Number: 737-25-1728
Original Issue: October 10, 2016
Revision 1: November 26, 2019
ATA System: 2523

SUBJECT: EQUIPMENT/FURNISHINGS - Passenger Compartment - Service Units - Passenger Service Unit (PSU) and Life Vest Panel Modification

BOEING SERVICE BULLETIN 737-25-1728

Revision Transmittal Sheet

**FIGURE 1: PASSENGER SERVICE UNIT MODIFICATION
(SHEET 1 OF 4)**

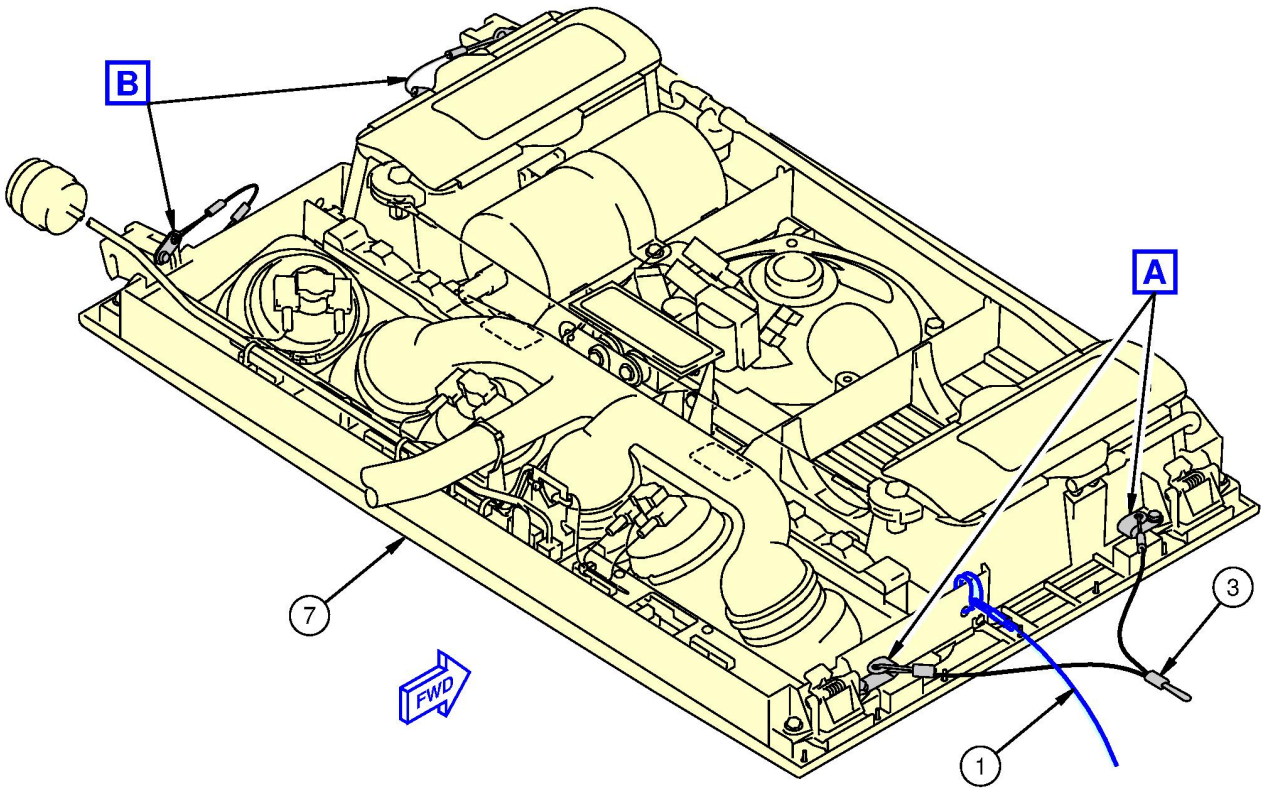
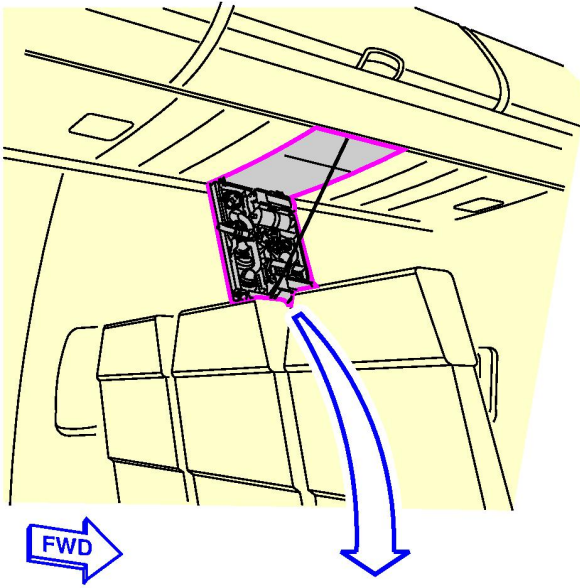
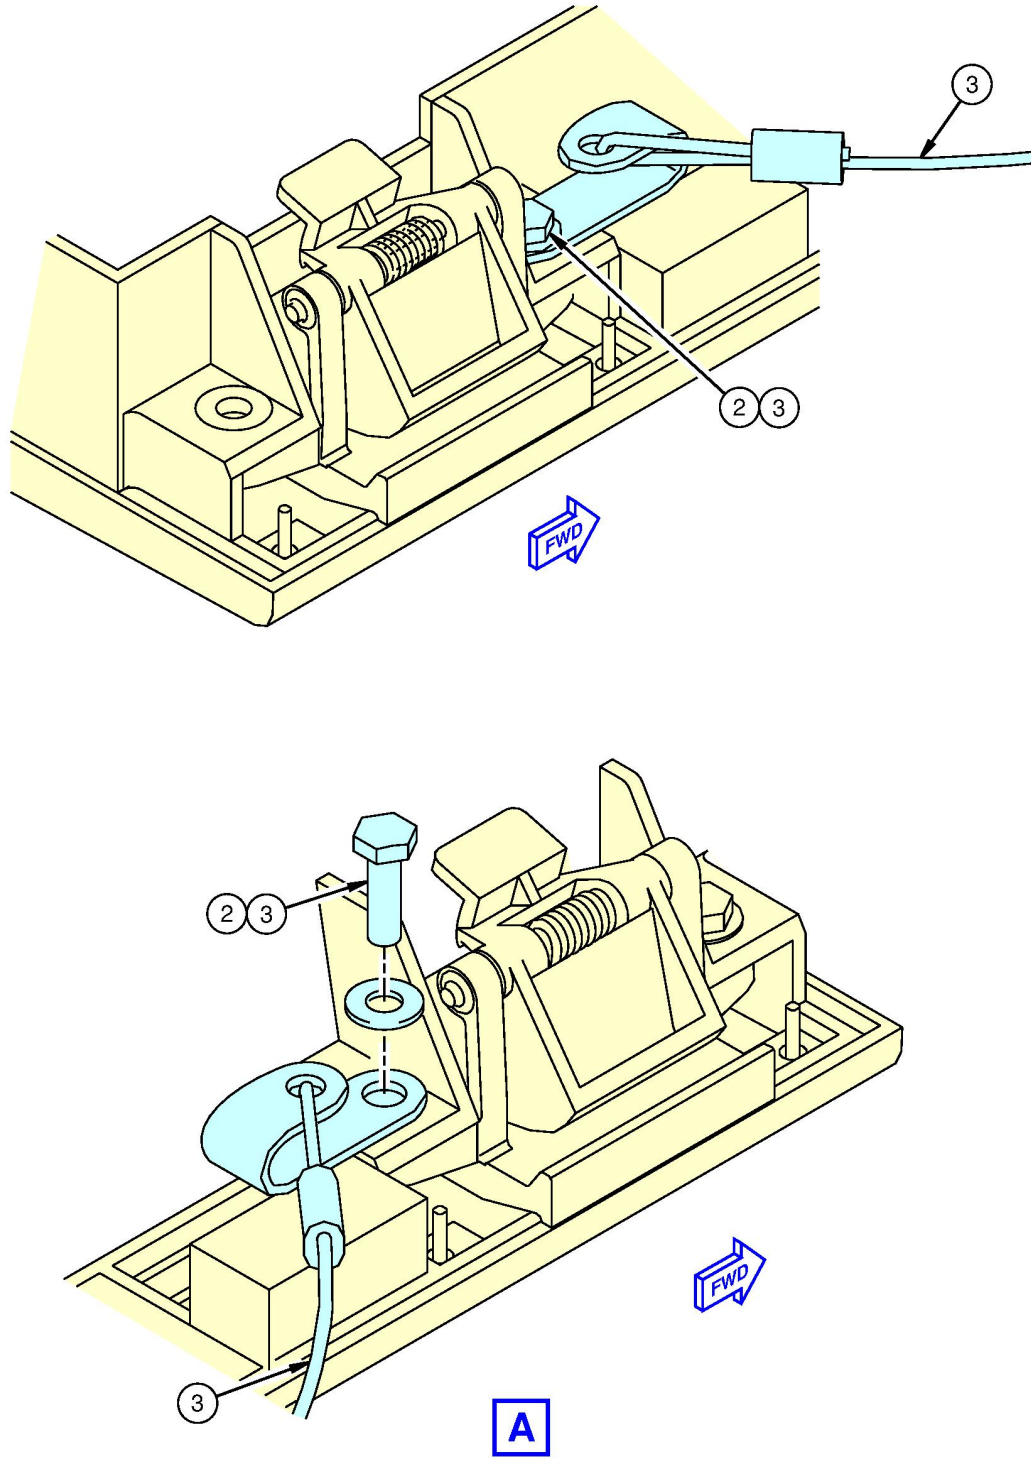
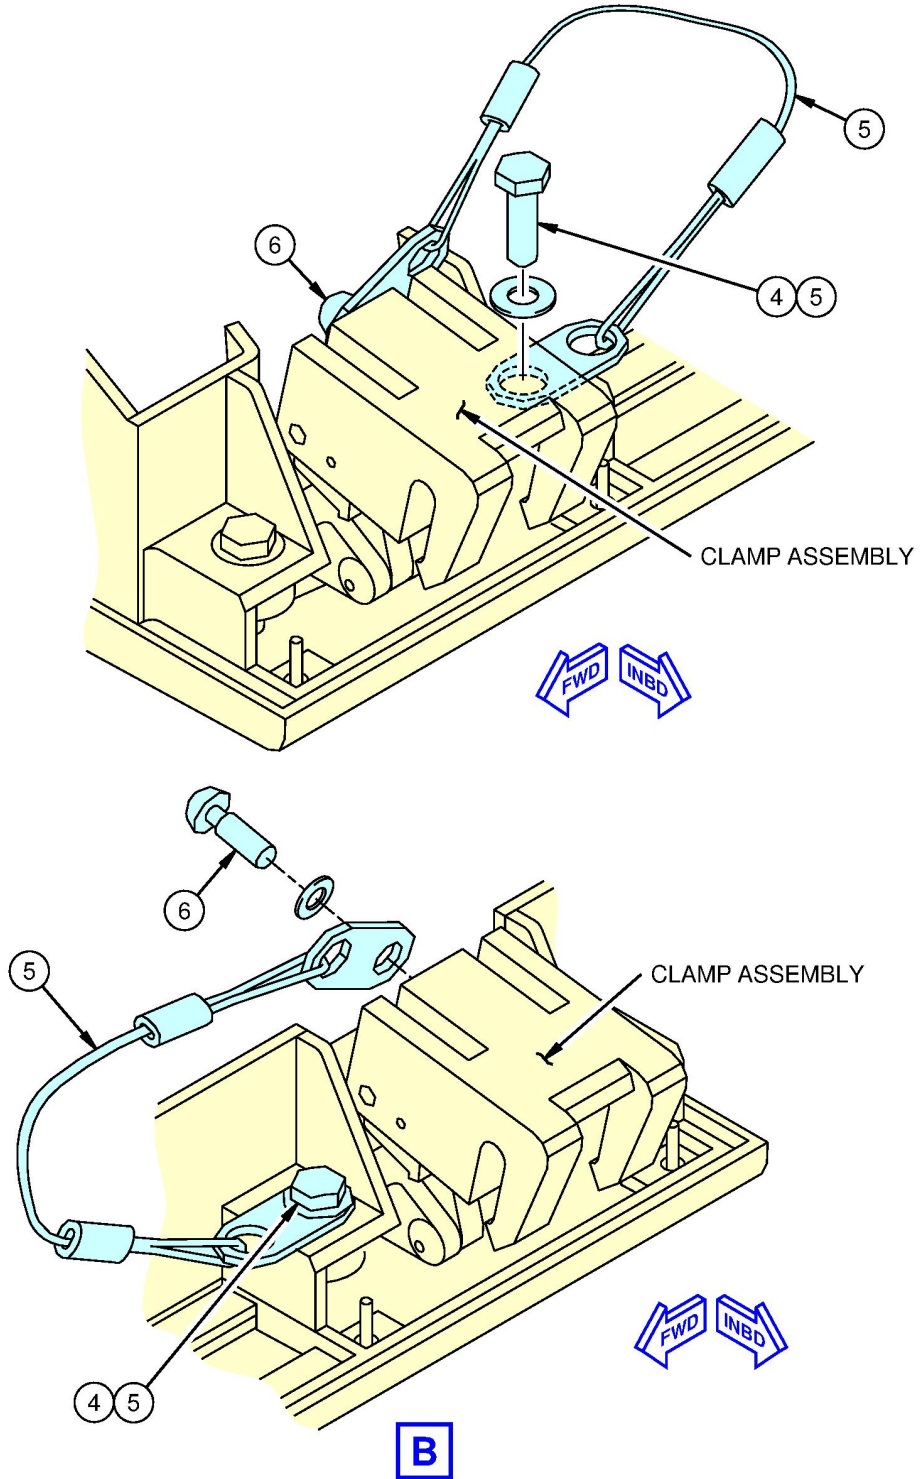
19. In Paragraph 3.A., General Information: Updated note 10.
20. In Paragraph 3.B., Work Instructions: Added instructions. Added applicability.
21. Figure 1: Added applicability.

This service bulletin installs additional lanyards for retention support on the Ultem PSUs and life vest panels. This will provide secondary support during survivable hull loss accidents and reduce the risk of injury to passengers and evacuation hindrance.

- b. RC - Install lanyard assemblies in accordance with FIGURE 1.
- c. Close the Passenger Service Unit (PSU). Refer to 737-300/400/500 AMM 25-23-61 as an accepted procedure.

- b. RC - Install lanyard assemblies in accordance with FIGURE 1.
- c. Close the Passenger Service Unit (PSU). Refer to 737-300/400/500 AMM 25-23-61 as an accepted procedure.

Step	Task	Name	Identification	Qty	More Data
1	Remove	LANYARD ASSEMBLY	417N3190-1	1	(a)
2	Remove / Keep	BOLT	-	2	
	Remove / Keep	WASHER	-	2	
3	Install (New)	LANYARD ASSY, SPRING CLIP, PSU	417A3003-9	1	(b)
	Install (Kept)	WASHER	-	2	
	Install (Kept)	BOLT	-	2	
4	Remove / Keep	BOLT	-	2	
	Remove / Keep	WASHER	-	2	
5	Install (New)	LANYARD ASSY, STD CLIP, PSU	417A3003-2	2	
	Install (Kept)	BOLT	-	2	
	Install (Kept)	WASHER	-	2	
6	Attach	LANYARD ASSY, STD CLIP, PSU	417A3003-2	-	(c)
	Apply	LOCTITE	222MS (MIL-S-46163A TYPE 11 GRADE M)	-	(d)
	Install (New)	SCREW	NAS1301-6-5	2	(e)
	Install (New)	WASHER FLAT	NAS1149C0316R	2	
7	Identify	PASSENGER SERVICE UNIT	417N3011-()	1	(f)

(f) Identify each modified Passenger Service Unit (PSU). Refer to APPENDIX A for the new part number of each modified PSU. A white pen or sticker may be used for better contrast with dark background. Refer to SOPM 20-50-10 as an accepted procedure.

FIGURE 2: LIFE VEST PANEL MODIFICATION
(SHEET 1 OF 5)

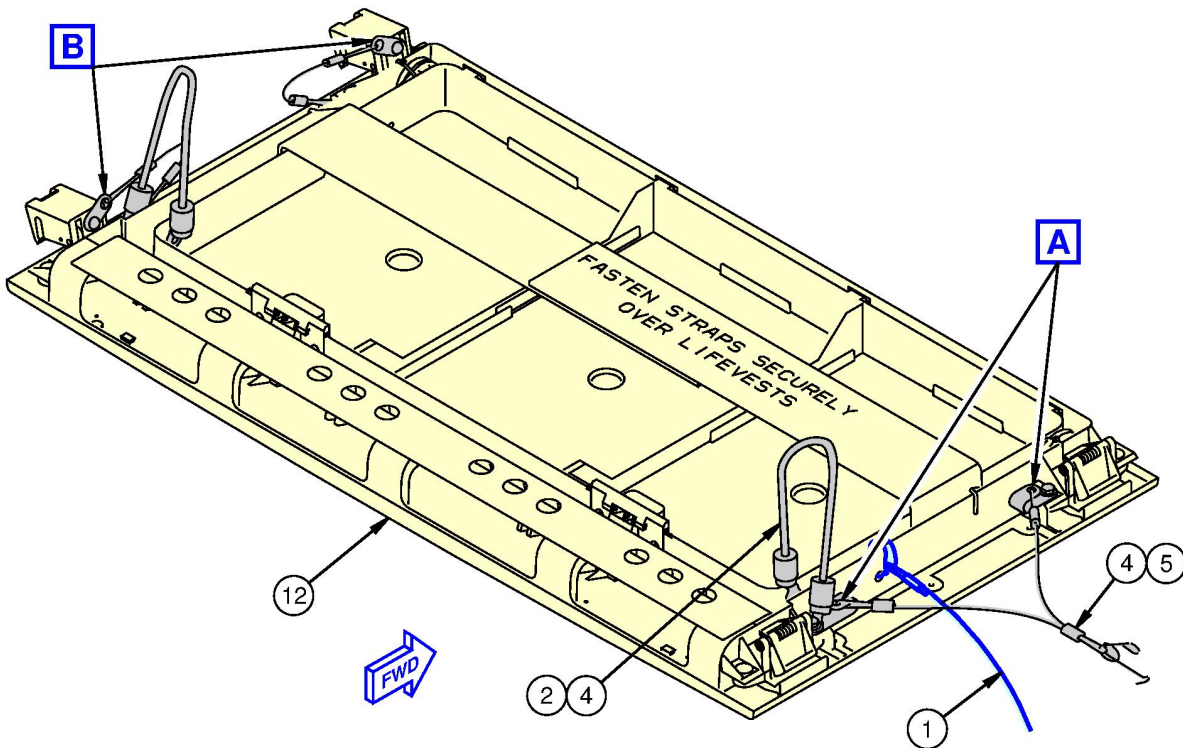
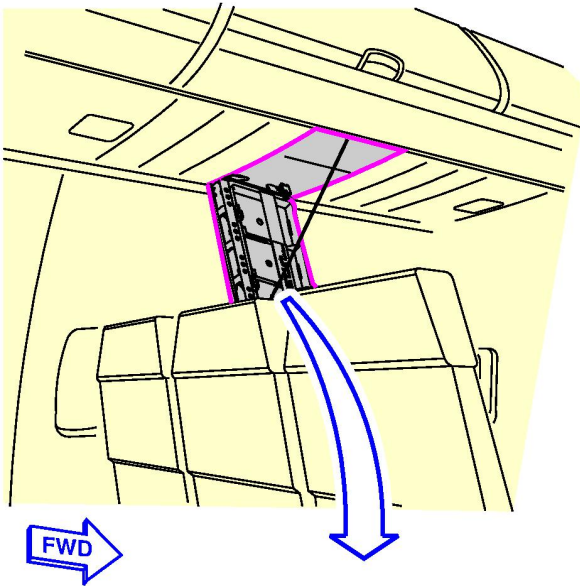
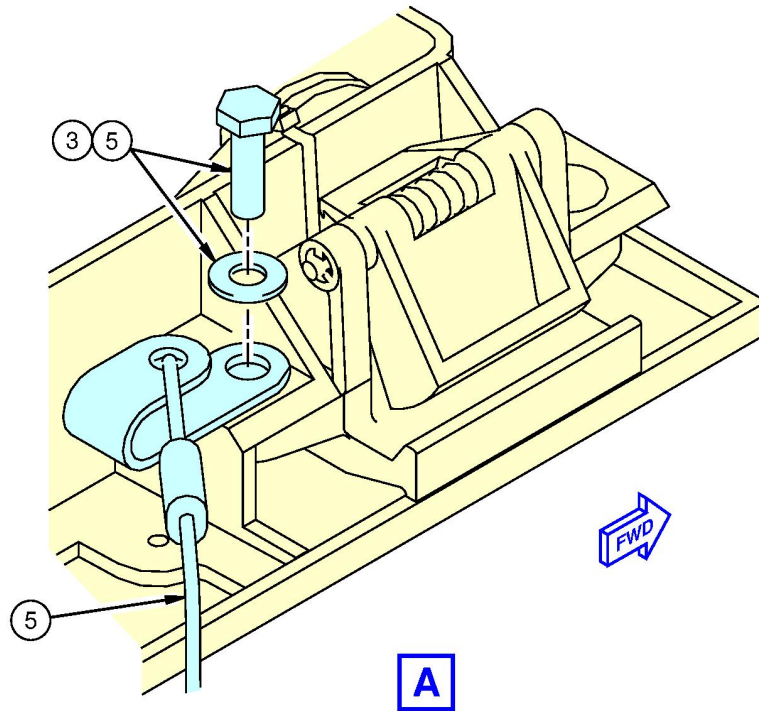
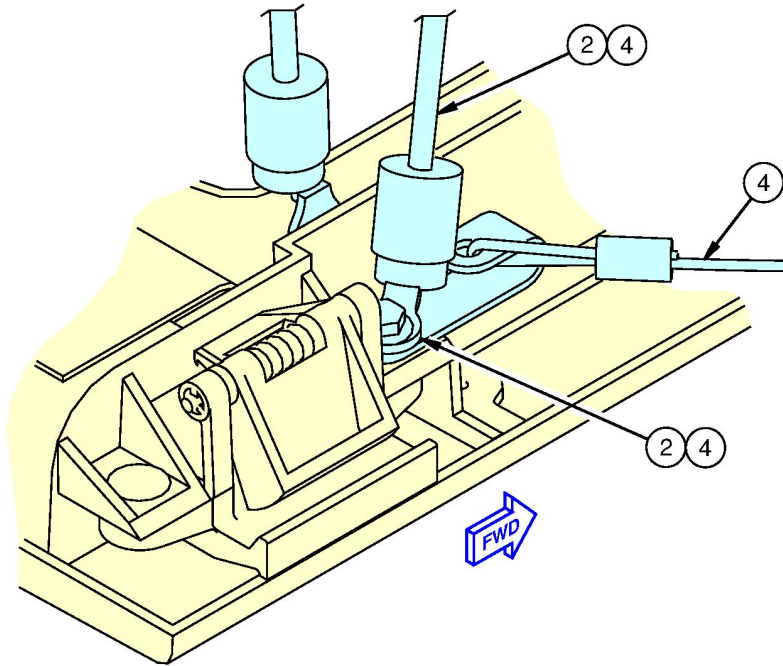
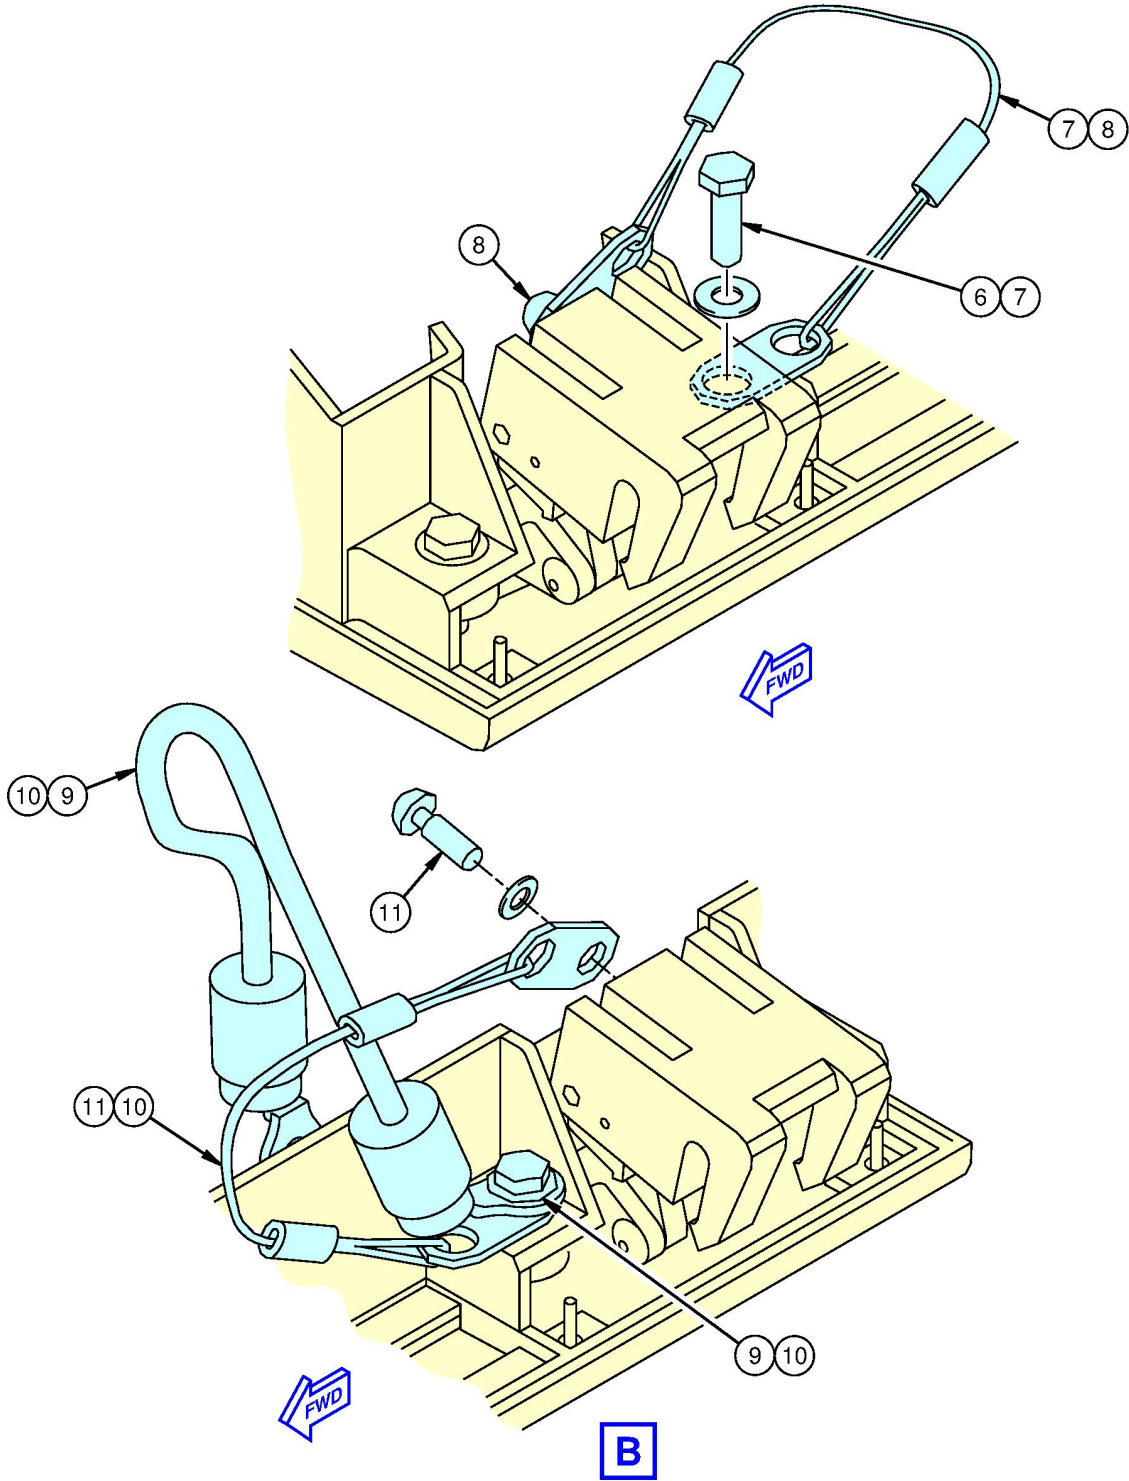
22. Figure 2: Added applicability. Changed footnote.
23. Appendix A: Added information.
24. Appendix B: Added information.
25. Appendix C: Added new Appendix C and moved part demand intent form to Appendix D.

- b. RC - Install lanyard assemblies in accordance with FIGURE 2.
- c. Close the Life Vest Panel. Refer to 737-300/400/500 AMM 25-23-61.

- a. Lower the Life Vest Panel. Refer to 737-300/400/500 AMM 25-23-61 as an accepted procedure.
- b. RC - Install lanyard assemblies in accordance with FIGURE 2.
- c. Close the Life Vest Panel. Refer to 737-300/400/500 AMM 25-23-61.

Step	Task	Name	Identification	Qty	More Data
1	Remove	LANYARD ASSEMBLY	417N3190-1	1	(a)
2	Remove	BOLT	BACS12HN08-6	1	
	Remove / Keep	WASHER	-	1	
	Remove / Keep	LIFE VEST DOOR LANYARD	417N3190-17	1	
3	Remove / Keep	BOLT	-	1	
	Remove / Keep	WASHER	-	1	
4	Install (New)	LANYARD ASSY, SPRING CLIP, PSU	417A3003-9	1	(b)
	Install (Kept)	LIFE VEST DOOR LANYARD	417N3190-17	1	(c)
	Install (New)	BOLT	BACS12HN08-8	1	(i)
	Install (Kept)	WASHER	-	1	
5	Attach	LANYARD ASSY, SPRING CLIP, PSU	417A3003-9	-	(d)
	Install (Kept)	BOLT	-	1	
	Install (Kept)	WASHER	-	1	
6	Remove / Keep	BOLT	-	1	
	Remove / Keep	WASHER	-	1	
7	Install (New)	LANYARD ASSY, STD CLIP, PSU	417A3003-2	1	
	Install (Kept)	BOLT	-	1	
	Install (Kept)	WASHER	-	1	
8	Attach	LANYARD ASSY, STD CLIP, PSU	417A3003-2	-	(e)
	Apply	LOCTITE	222MS (MIL-S-46163A TYPE 11 GRADE M)	-	(f)
	Install (New)	SCREW	NAS1301-6-5	1	(g)(i)
	Install (New)	WASHER FLAT	NAS1149C0316R	1	(i)

Step	Task	Name	Identification	Qty	More Data
9	Remove	BOLT	-	-	
	Remove / Keep	WASHER	-	1	
	Remove / Keep	LIFE VEST DOOR LANYARD	417N3190-17	1	
10	Install (New)	LANYARD ASSY, STD CLIP, PSU	417A3003-2	1	
	Install (Kept)	LIFE VEST DOOR LANYARD	417N3190-17	-	(c)
	Install (New)	BOLT	BACS12HN08-8	1	(i)
	Install (Kept)	WASHER	-	1	
11	Attach	LANYARD ASSY, STD CLIP, PSU	417A3003-2	-	(e)
	Apply	LOCTITE	222MS (MIL-S-46163A TYPE 11 GRADE M)	-	(f)
	Install (New)	SCREW	NAS1301-6-5	1	(g)(i)
	Install (New)	WASHER FLAT	NAS1149C0316R	1	(i)
12	Identify	LIFE VEST PANEL	417N3070-() OR 417N3014-()	1	(h)

(h) Identify each modified Life Vest Panel. For Group 2, refer to APPENDIX B for the new part number of each modified Life Vest Panel. For Group 3, refer to APPENDIX C for the new part number of each modified Life Vest Panel. A white pen or sticker may be used for better contrast with dark background. Refer to SOPM 20-50-10 as an accepted procedure.
